STAFF REPORT TO THE DESIGN REVIEW COMMITTEE

File No. Z0057-25

Applicant's Proposal: The applicant proposes to redesign an existing site; including a new quadplex, parking area, walkways, enhanced landscaping and the conversion of the existing dwelling into a duplex. There will be a total of six (6) dwelling units on site.

Site Address: 18900 SE Mildred St., Milwaukie, OR 97267

Building Elevation

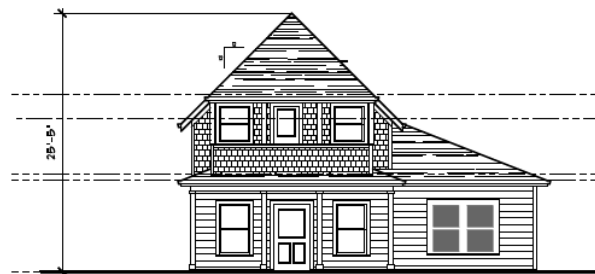
The proposed quadplex will have a roof pitch of 5:12 and staff's review of the plans demonstrate that most of the building will include an eave overhang of 24 inches. A condition of approval is warranted to ensure that a minimum of 24-inch eave overhang is provided for the entire quadplex, or the applicant can request a design modification pursuant to ZDO Section 1005.06.

4. The eaves of the quadplex shall overhang at least 24 inches. [1005.03(D)]
